HISTORIC AND DESIGN REVIEW COMMISSION

HDRC CASE NO: 2021-324
ADDRESS: 909 N HACKBERRY ST
LEGAL DESCRIPTION: NCB 529 BLK 2 LOT N 92.5 FT OF 13 & 14
ZONING: IDZ-1, H
CITY COUNCIL DIST.: 2
DISTRICT: Dignowity Hill Historic District
APPLICANT: Michael Garansuay/GARANSUAY MICHAEL S & TERESA P
OWNER: Michael Garansuay/GARANSUAY MICHAEL S & TERESA P
TYPE OF WORK: New construction of two, 2-story residential structures and two, 1-story residential structures
APPLICATION RECEIVED: June 30, 2021
60-DAY REVIEW: Not applicable due to City Council Emergency Orders
CASE MANAGER: Edward Hall
REQUEST:

The applicant is requesting a Certificate of Appropriateness for approval to construct two, 2-story residential structures and two, 1-story residential structures on the vacant lot at 909 N Hackberry, located within the Dignowity Hill Historic District.

E2 BUILDING A ELEVATION, SOUTH
1/4" = 1'-0"

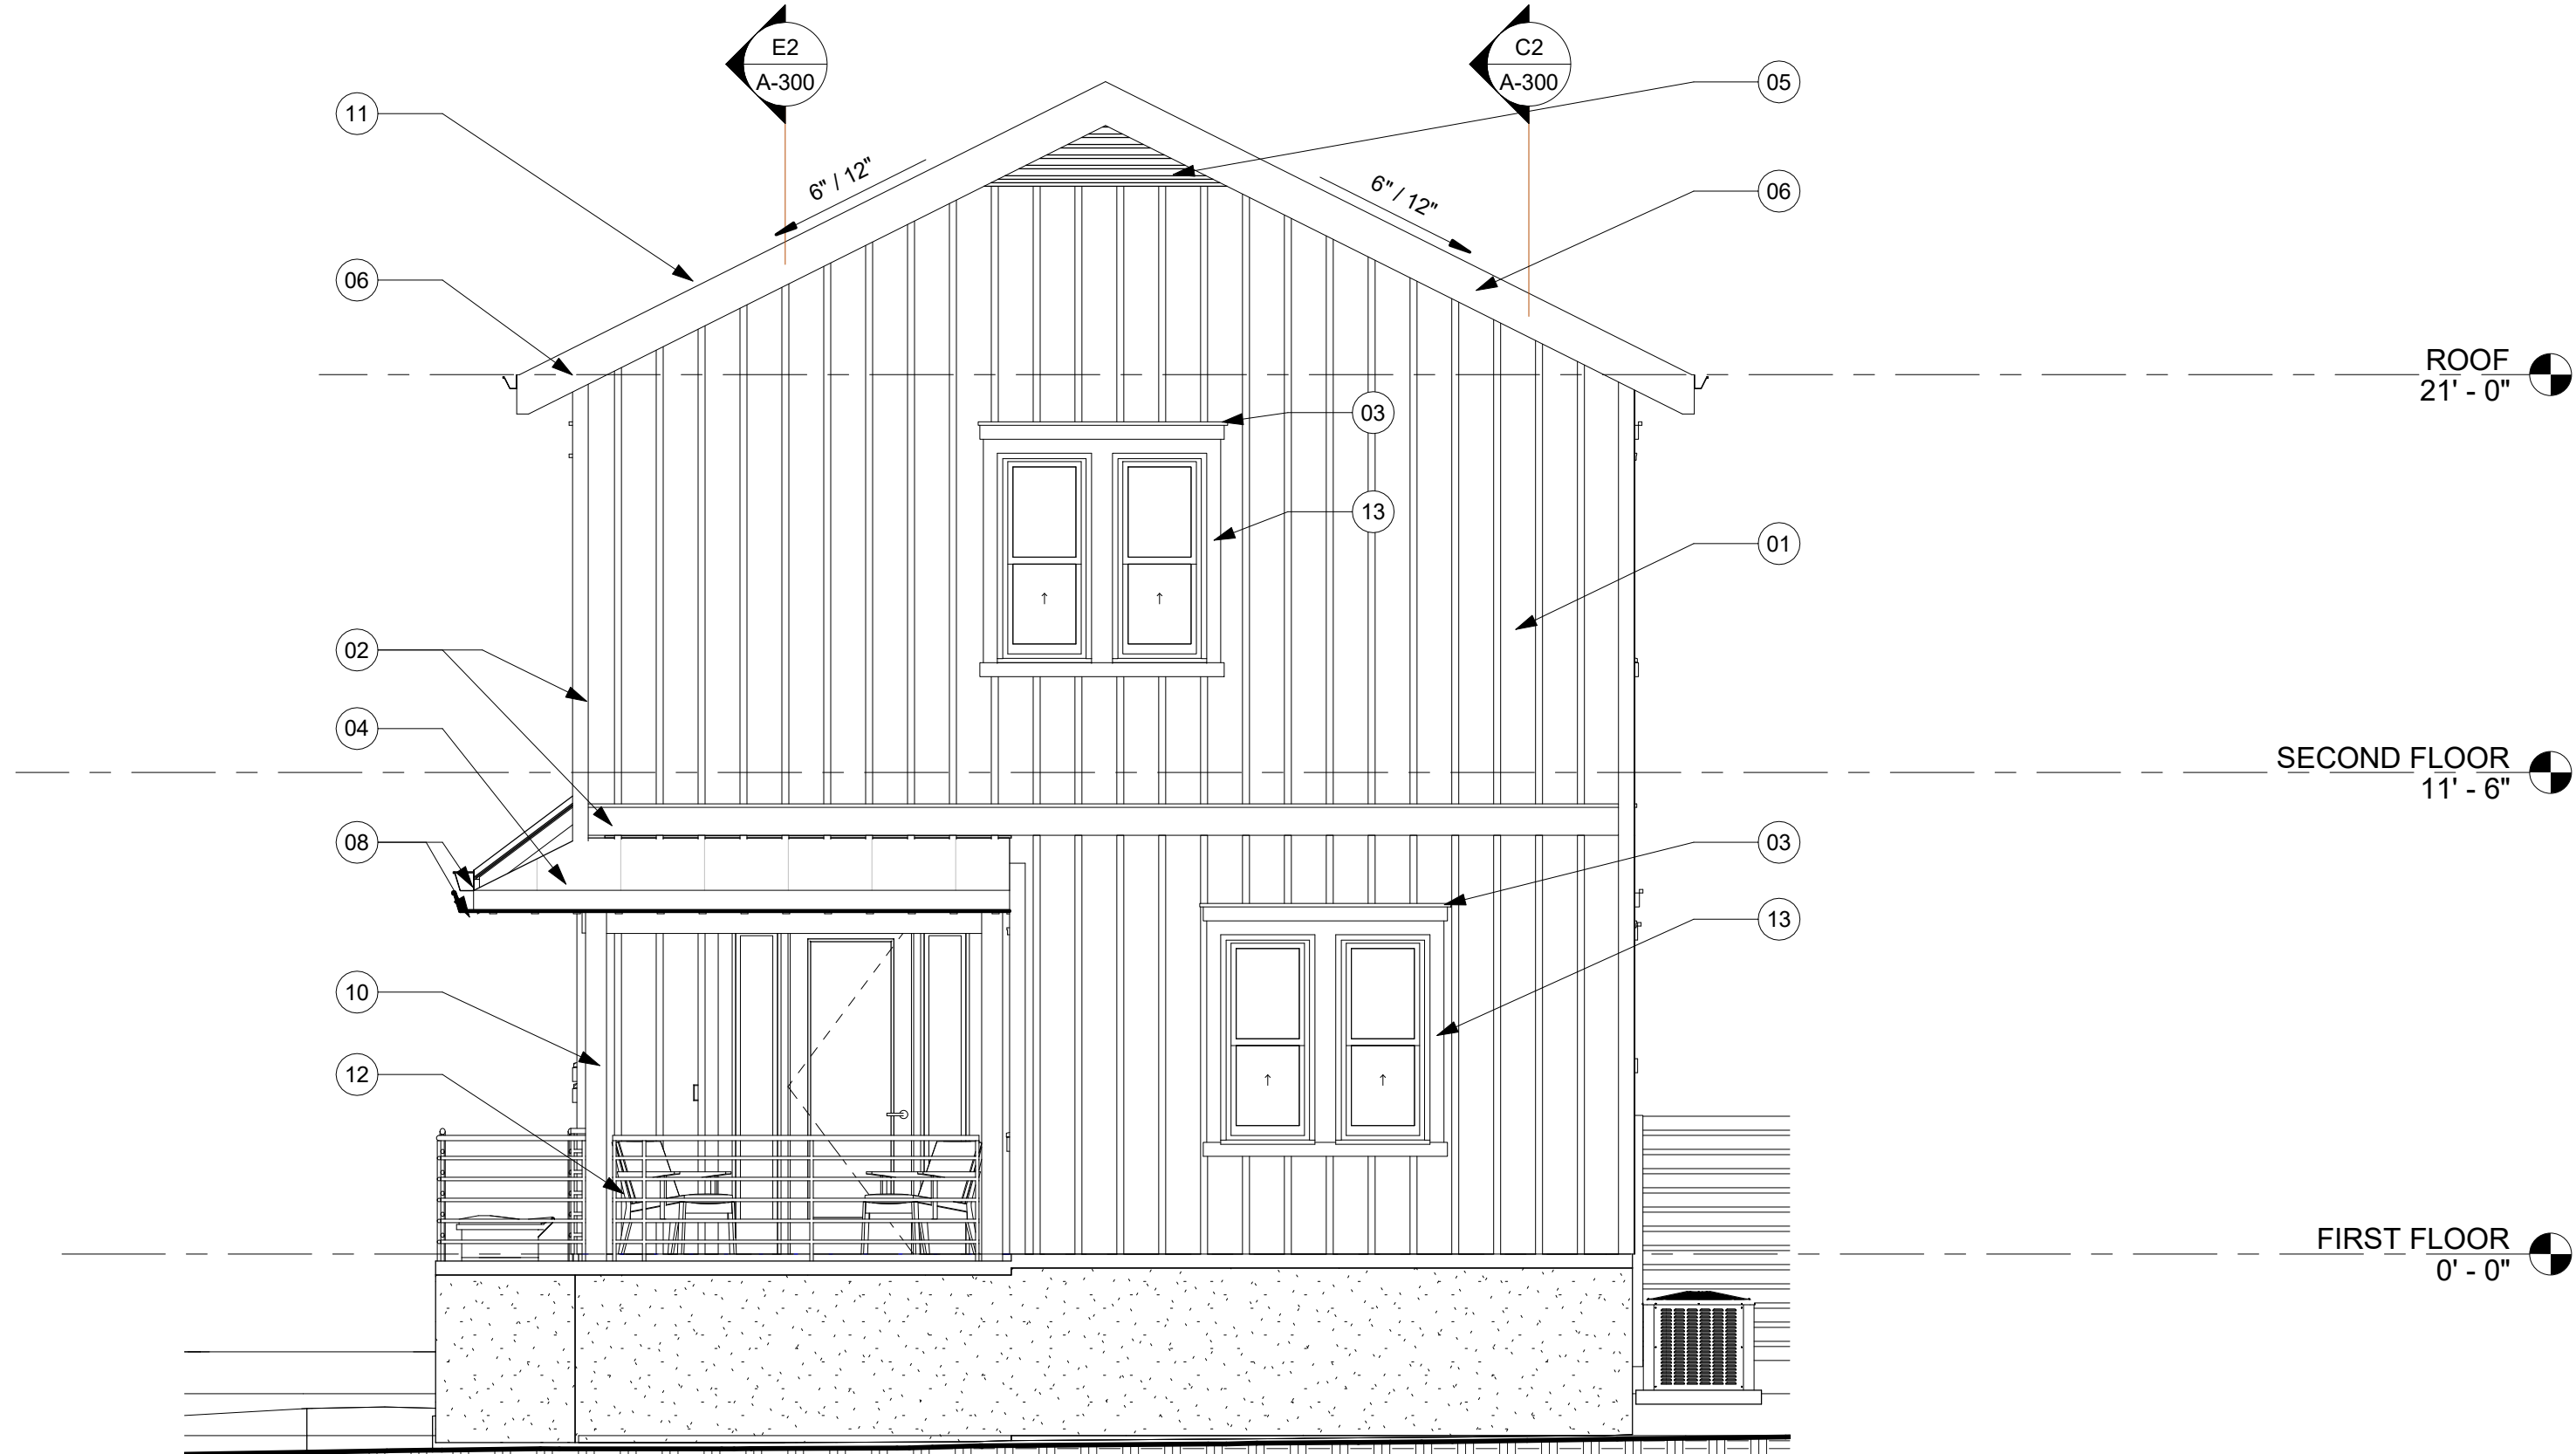
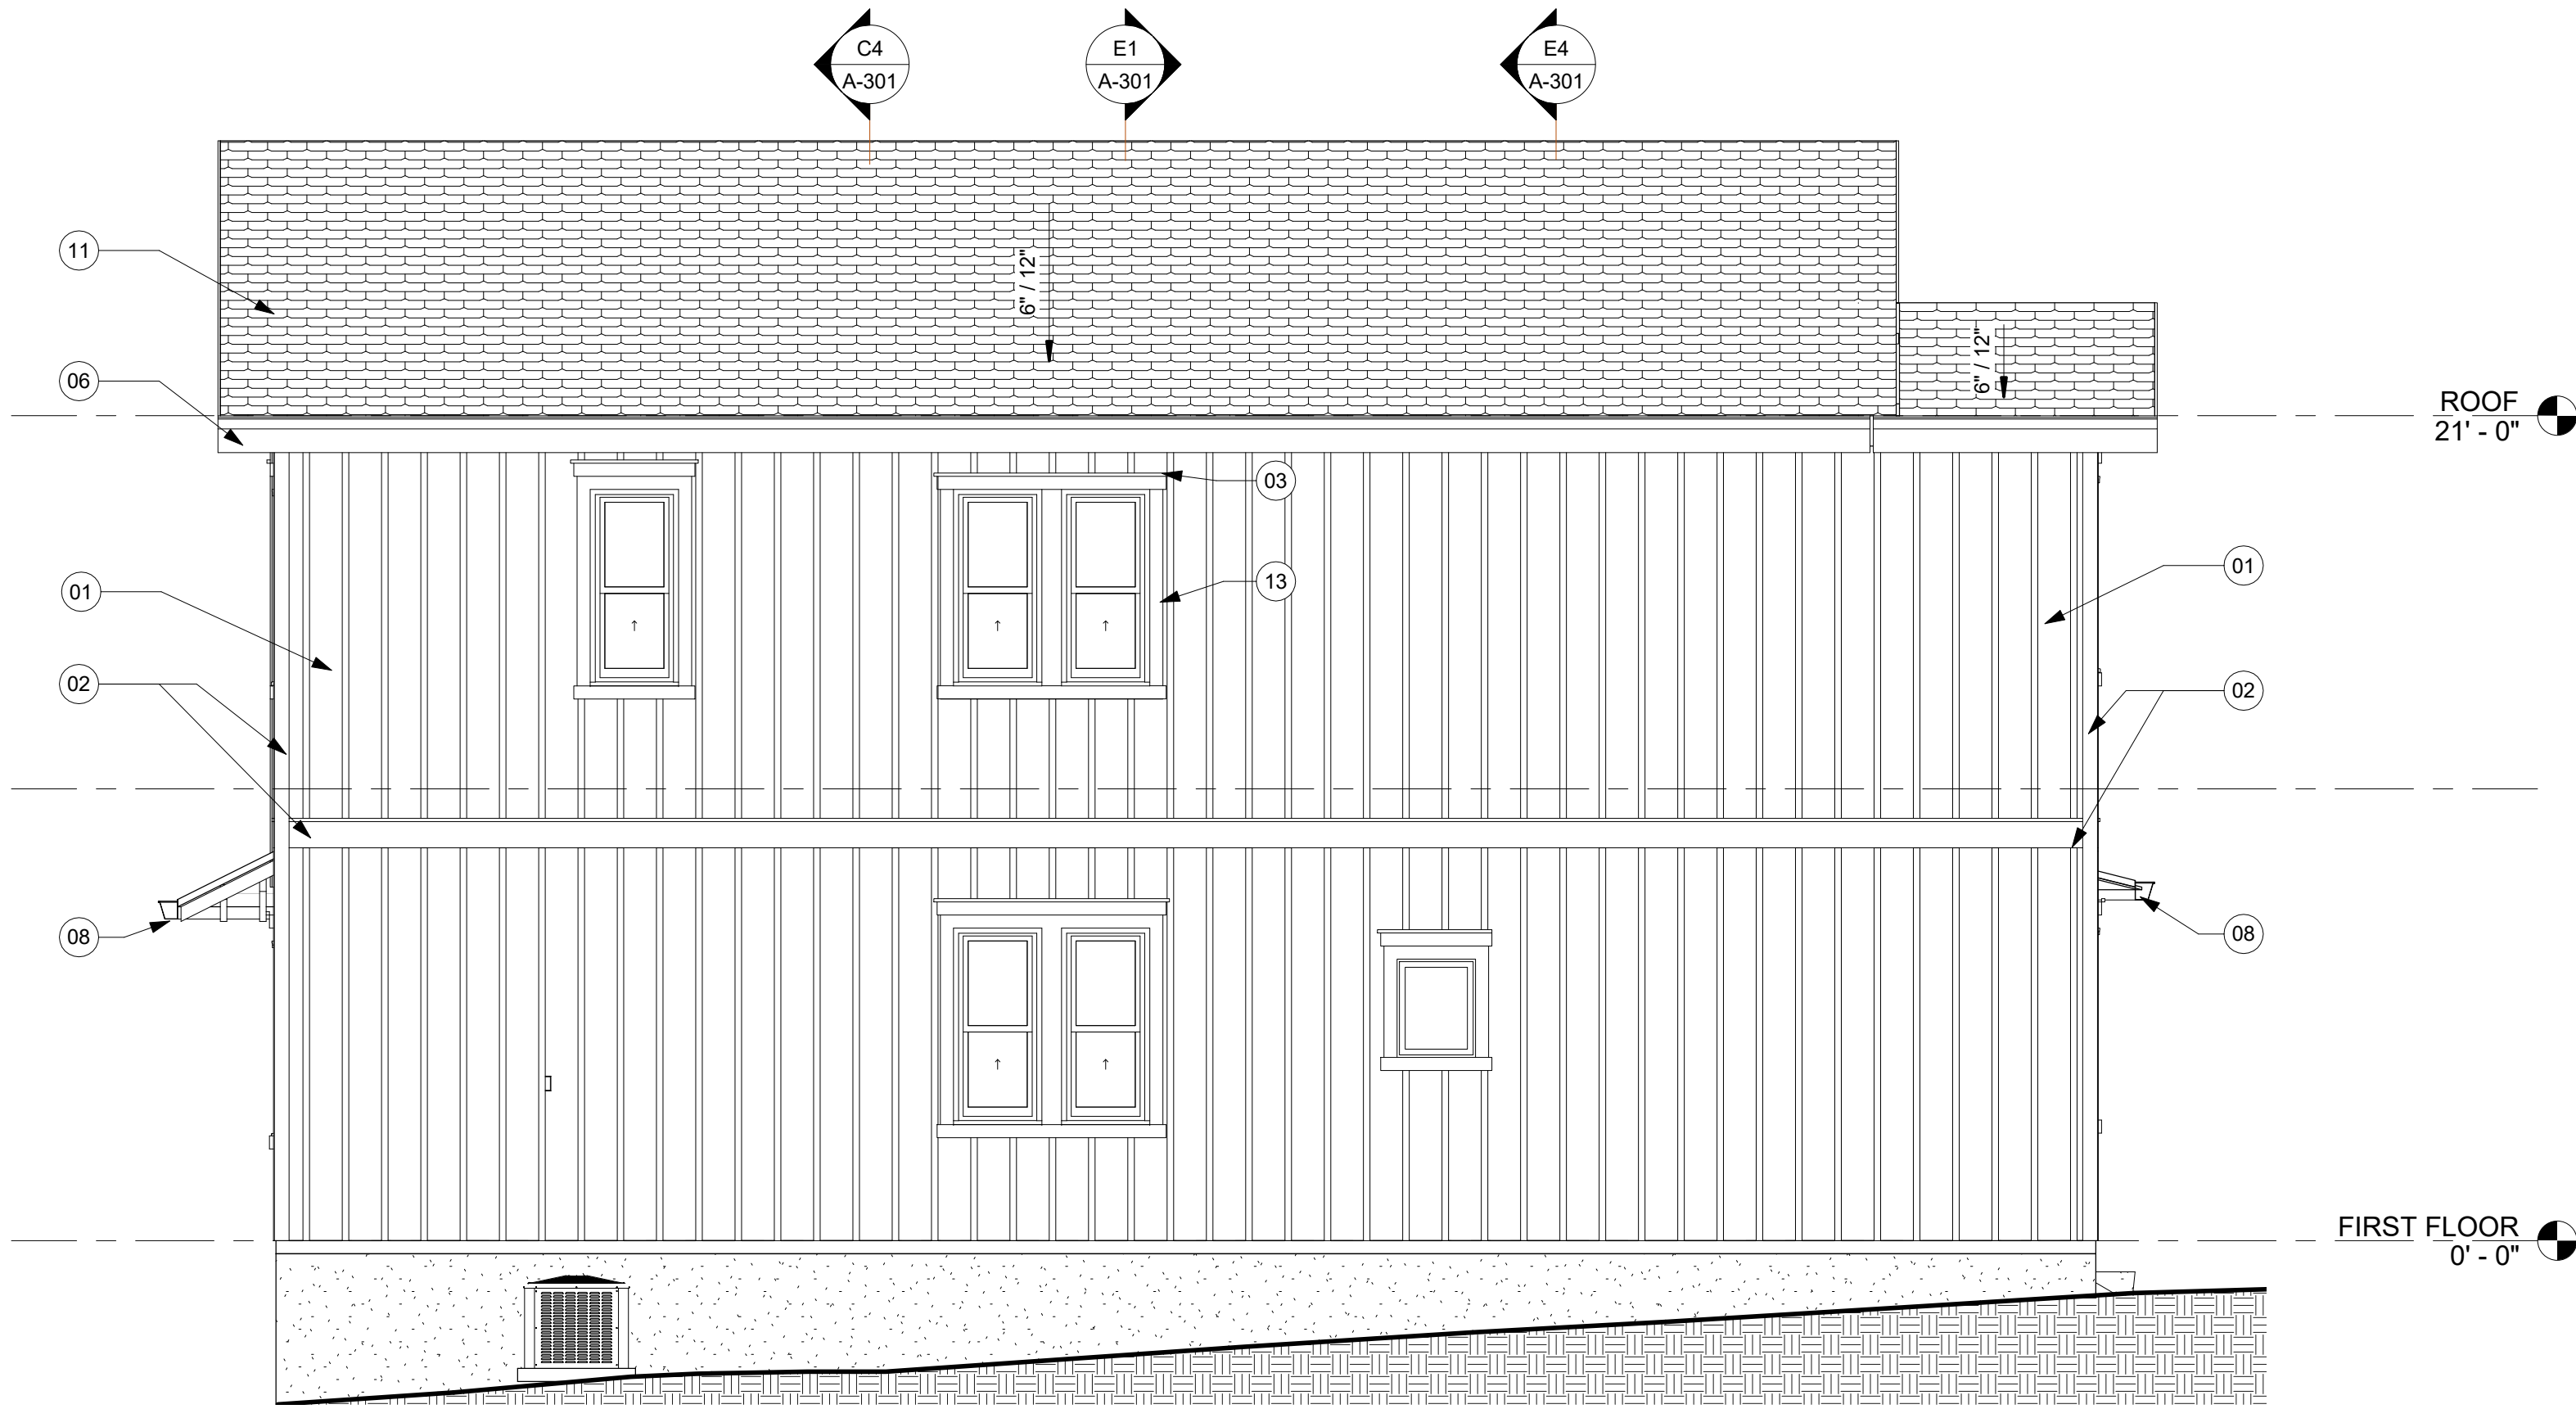
- l. **WINDOW & DOOR OPENINGS** – Per the Guidelines for New Construction 2.C.i., window and door openings with similar proportions of wall to window space as typical with nearby historic facades should be incorporated into new construction. Generally, staff finds the proposed window openings to be atypical in size with those found historically within the district. Staff finds that window groupings, heights, and widths should be modified to be consistent with those found historically within the district. As proposed, windows appear to feature widths and overall heights that are smaller in size as those found historically within the district. Additionally, staff finds that façade locations that are void of fenestration should be modified to feature window openings, specifically the south elevation of building A.
